**Meeting Date:** Tuesday 16 April 2013  
**Location:** Committee Room 2, Level 5, Civic Centre, 1 Devlin Street, Ryde  
**Time:** 5.00pm

Item	Page
1 CONFIRMATION OF MINUTES - Meeting held on 2 April 2013.....	1
2 22 MONS AVENUE, WEST RYDE. LOT 23, Section C, DP 2322. Local Development Application for demolition, construction of a residential flat building with six (6) apartments and basement car parking for eight (8) cars. LDA2012/0454. <i>INTERVIEW 5.00PM</i> .....	4
3 93-95 VIMIERA ROAD, EASTWOOD. LOT 9 SP 68723. Section 96 application to delete condition of consent requiring compliance with (former) State Environmental Planning Policy No 5 - Housing for Older People or People with Disabilities. MOD2012/122. ....	104
4 66A PELLISIER ROAD, PUTNEY. LOT B DP 419543. Local Development Application for new dual occupancy. LDA2012/0106. <i>INTERVIEW 5.10PM</i> .....	126

**1 CONFIRMATION OF MINUTES - Meeting held on 2 April 2013**

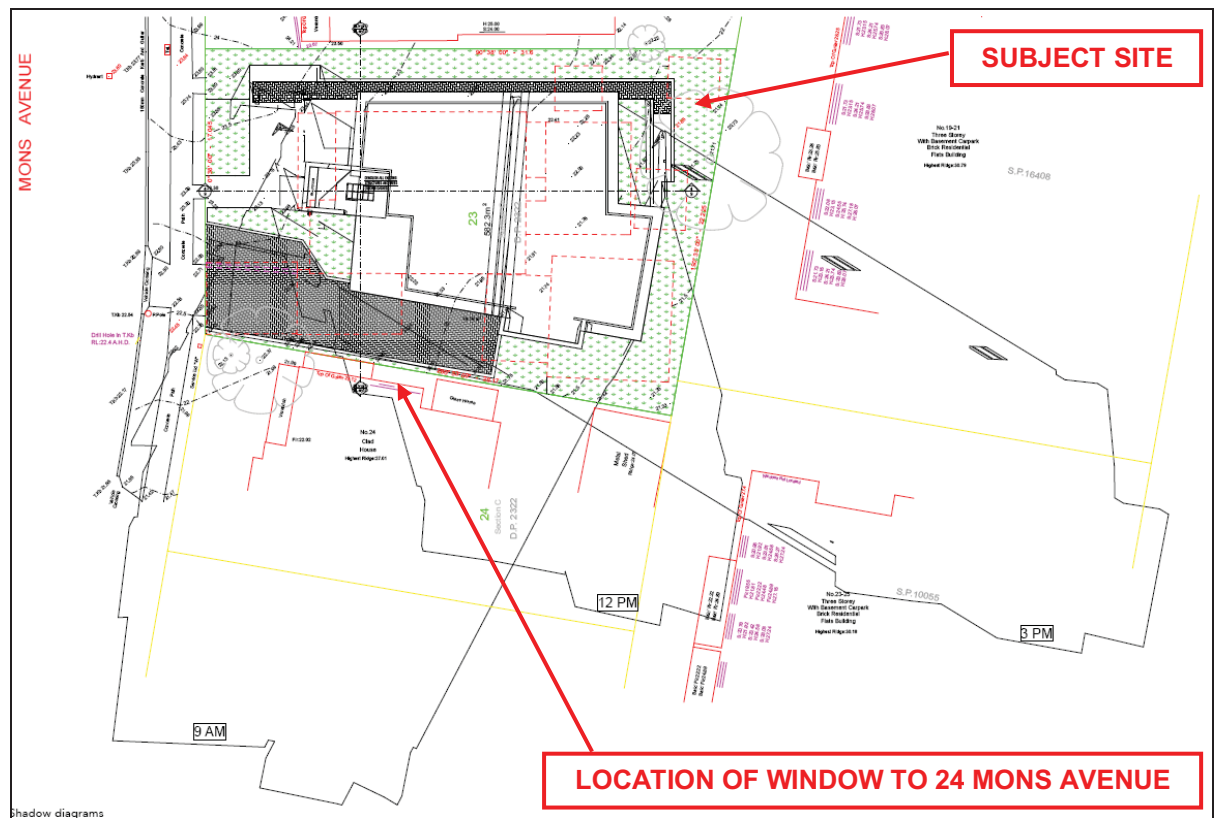
There is no quantitative control in Section 3.4 of the RDCP (for "*residential flat development*") regarding solar access. The quantitative control is drawn from the RFDC for high density residential development. As No. 24 Mons Avenue is a single dwelling house, the RFDC does not strictly apply to the existing built form. However, Section 3.3 of the RDCP prescribes that windows in dwellings to the north-facing living areas are to receive at least 3 hours of sunlight between 9:00am and 3:00pm on 21 June over a portion of their surface. Furthermore, this section requires sunlight to at least 50% of the principal area of ground level private open space of adjacent properties, not to be reduced to less than two (2) hours between 9:00am and 3:00pm on June 21.

In relation to No. 24 Mons Avenue, the shadow diagrams submitted with the application demonstrate that the window on the north facing elevation, will receive approximately 3 hours of solar access between 9:00am and 3:00pm in mid-winter.

However, the level of solar access to the rear private open space of the dwelling appears to be adversely impacted. The elevation shadow diagrams submitted do not fully demonstrate the shadow impact to this area. The plan shadow diagram (as above) does not provide enough information to quantify the exact impact. A plan showing the impact on an hourly basis between 9:00am and 3:00pm would be appropriate in this regard. Based on the limited information provided, it is likely that the amount of solar access to the rear private open space of No. 24 Mons Avenue is reduced to less than two (2) hours (to at least 50% of the area) between 9:00am and 3:00pm in mid-winter. This is not considered to be satisfactory and impacts on the amenity of this dwelling.

**Clause 4.3(2) Building Height**

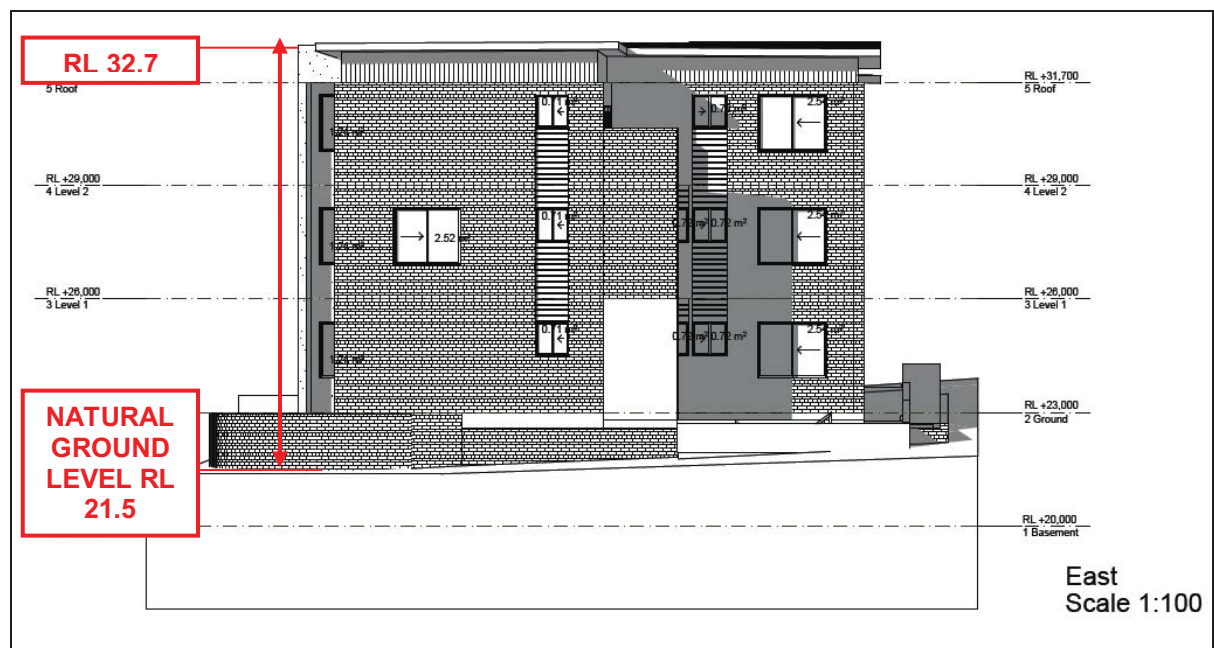
The maximum height of the development as shown on the architectural plans (section plan) is 10.75 metres. However, the point at which the section was taken does not appear to have been taken from where the lowest natural ground level is. Therefore, based on the survey and other information provided, this calculation appears to be inaccurate.

At the south-east corner of the building, based on the survey information provided, natural ground level appears to be at RL 21.5 and the maximum RL of the building at that point is RL32.7 (*"the highest point of the building"*). Refer to the figure below:

The total maximum building height is therefore approximately 11.2 metres. The proposed development complies with the maximum building height control under the RLEP.

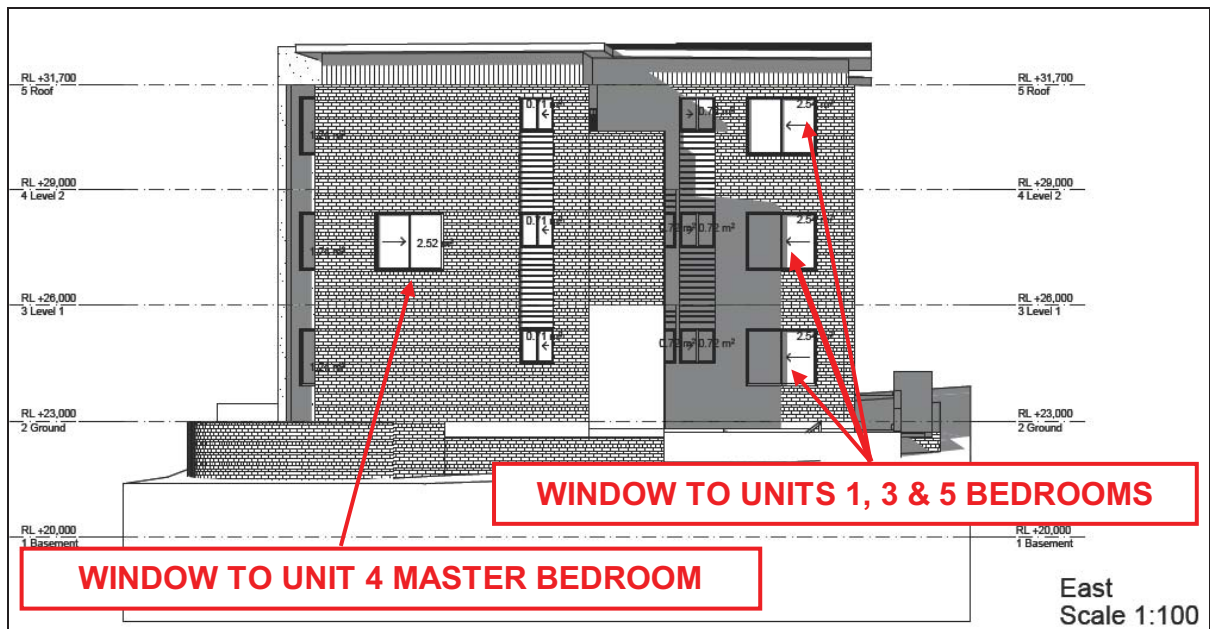
- The window to the master bedroom of proposed Unit 4 has an east facing window with a sill height of approximately RL 26.9. Refer to the figure below.

This window is partly offset from a window at the upper level of No. 19-21 Station Street with a sill height of RL 26.83. The separation distance of these two (2) windows is 9 metres. A potential impact on the privacy of residents in these two (2) units could result from an oblique view. This issue could potentially be resolved by a condition of consent requiring either a sill height of 1.6 metres (or obscure glazing to this height within the window pane).

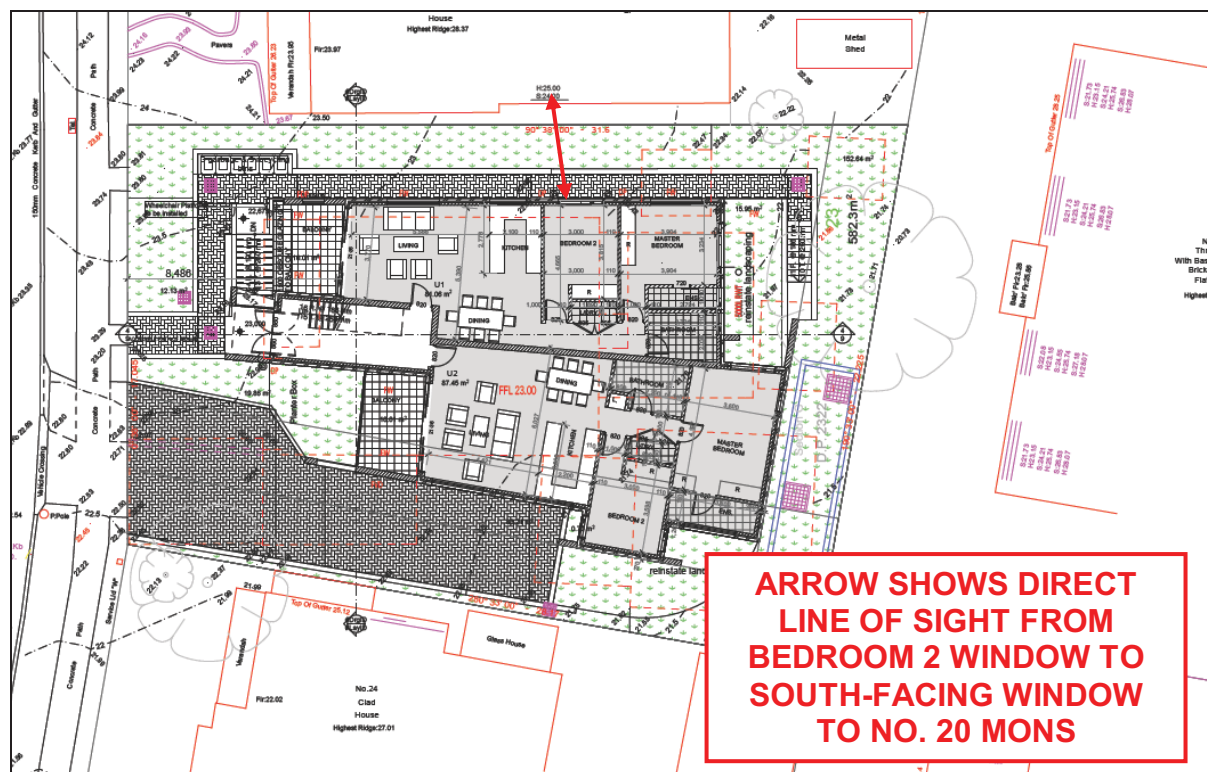
- The proposed separation between the west-facing balconies to No. 19-21 Station Street and the rear bedrooms of the proposed development (Units 1, 3 and 5 as shown in the figure above) is 11 metres. A small splay wall and landscaping has been proposed as a mitigation measure. The splay wall and landscaping will not adequately mitigate any "overlooking" that may result from the lack of separation distance to meet the RFDC guidelines. The tree could provide some screening. However, concerns are raised regarding the health of this tree and as no supporting information has been submitted to Council to confirm the tree can be retained and will not be impacted by excavation, privacy remains as a concern in this regard. A condition could potentially be imposed to require the windows of the east-facing master bedrooms to be either high sill or glazed.

- The lack of separation distances and the non-compliant RDCP rear setback brings the common open space area at the rear of the site closer to the rear boundary and within closer view of the windows and balconies (west-facing) of No. 19-21 Station Street. This is unacceptable.

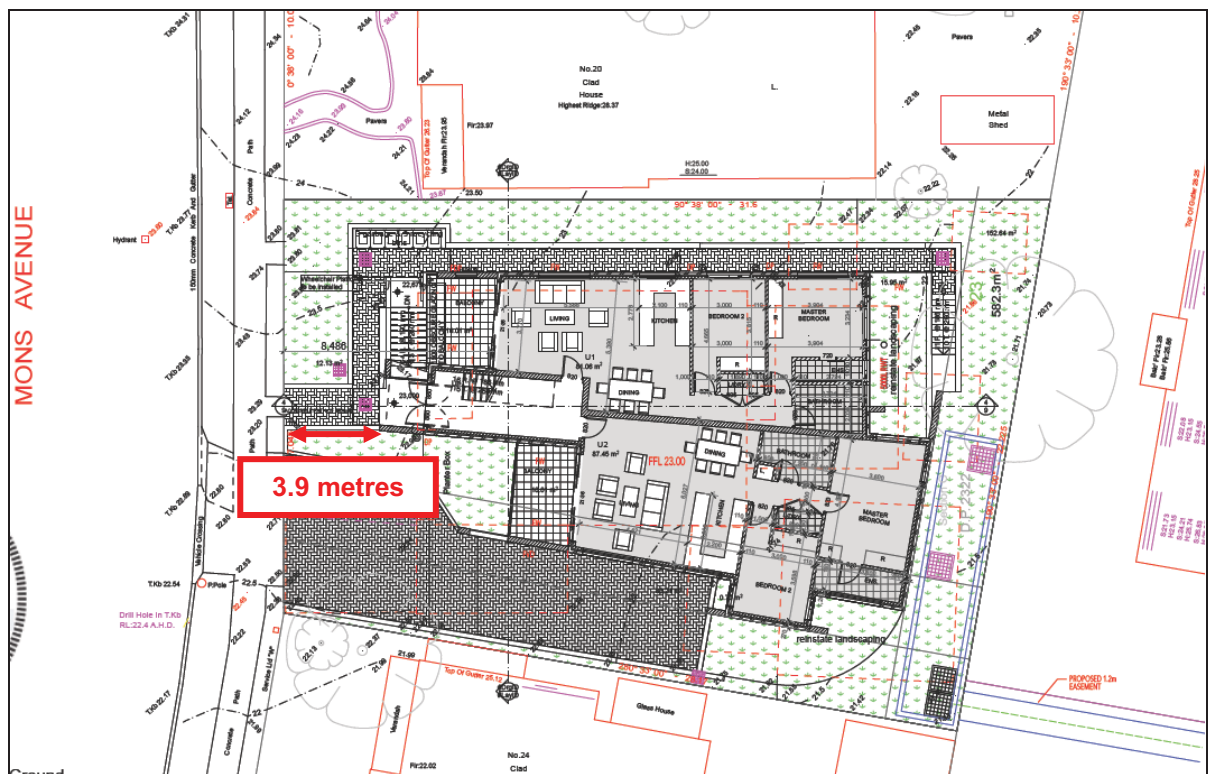
The level of non-compliance is minor and is restricted to a small part of the building. However, due to the non-compliance, consideration of the impact of this projection and additional storey is necessary. Comments are below:

- The building in this location still complies with the maximum building height under the RLEP.
- The non-compliance primarily results from the topography of the site and the fall of the land to the south-eastern part of the site.

- The building presents as a three (3) storey building from the street and the north and with boundary fencing to 1.8 metres and landscaping, the building will not present as a true four (4) storey development from the rear/east and south of the site.

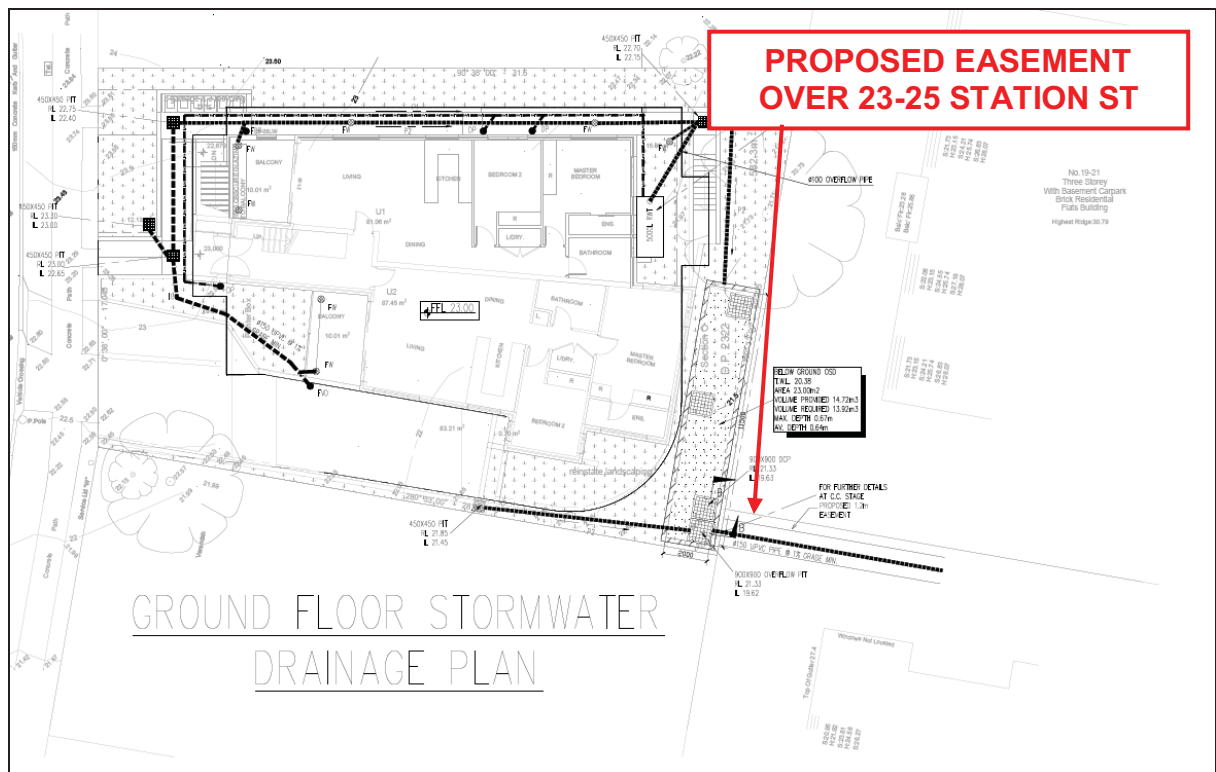
However, at the very least, consent should be granted by the owner(s) of No. 23-25 Station Street.

The amended documentation submitted to Council on 16 February 2013 included a series of emails between Strathfield Strata Management and the Architect regarding the easement. This correspondence appears to relate to No. 19-21 Station Street, West Ryde, the relevance of which is unclear, as the stormwater plan submitted with the application (as amended) shows a stormwater easement across No. 23-25 Station Street. Refer to the stormwater plan extract below.

Failure to produce owners' consent or any evidence of negotiation with the owner(s) of No. 25 Station Street is unacceptable and included as a reason for refusal of this application.

**16) Tree Preservation**

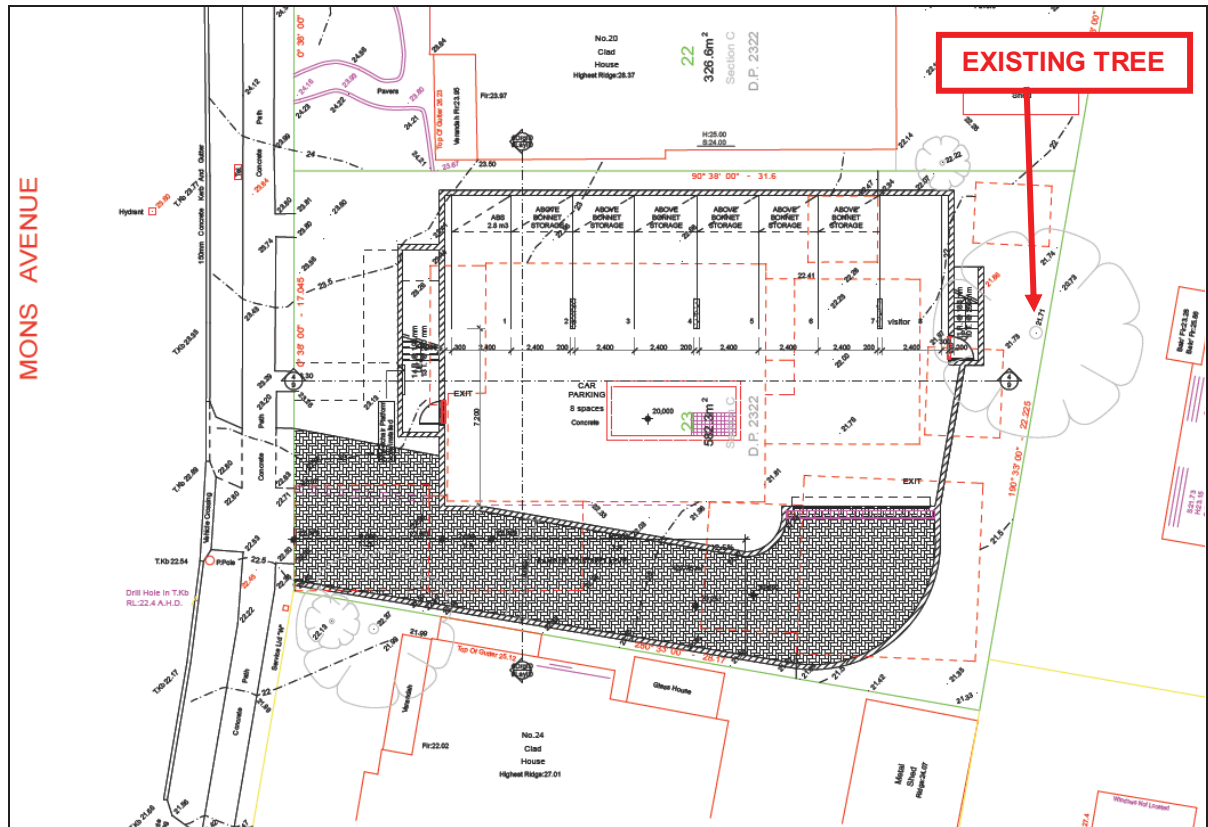
The existing tree at the rear of the site is proposed to be retained. However, the basement excavation and construction is within close proximity to the tree and no details have been submitted with this information to assess the potential impact and consider any required tree protection measures.

### Design of the Proposed Balcony to Unit 1

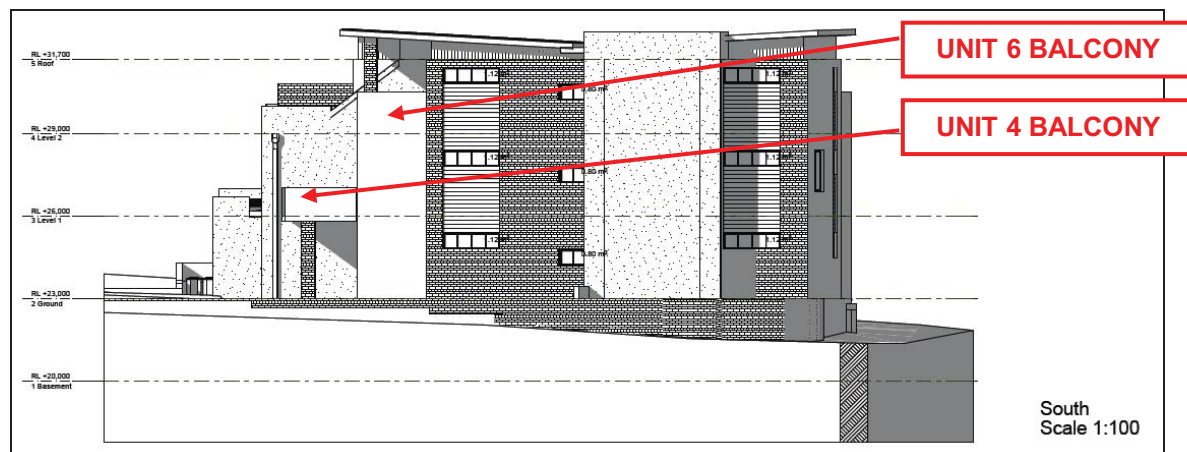
Earlier in this report reference was made to the design of the balcony to proposed Unit 1 at the ground floor level. Concerns regarding this balcony largely result from the close proximity to the fire stair from the basement. This staircase, which is considered to be a poor design outcome for reasons outlined earlier in this report, has the potential to create a general nuisance and subsequent amenity impact on the users of the balcony. A 1.5 metre high screen is proposed to the balcony (combined with 22.679 FFL of the stair podium, giving a 1.8 metre screen to Unit 1). However, as the fire stair is used as the only path of safe travel from the basement to the entrance of the building, it is reasonable to expect there will be a pedestrian activity in front of the balcony. A balcony screen can only achieve so much visual and acoustic screening.

The poor relationship of the stair to the balcony was raised at the pre-lodgement stage and in Council's request for further information letter and reconsideration of this part of the design was requested. The potential for nuisance from potential overlooking (which is still possible despite the balcony screen), noise from continuous pedestrian traffic and potential odour from the unenclosed bin store are matters that cannot be resolved via conditions. This element of the design is unsatisfactory and requires reconsideration in any future application.

The above is contrary to the objectives of Section 3.4 of the RDCP which encourages a high architectural standard and requires residential amenity to be enhanced.
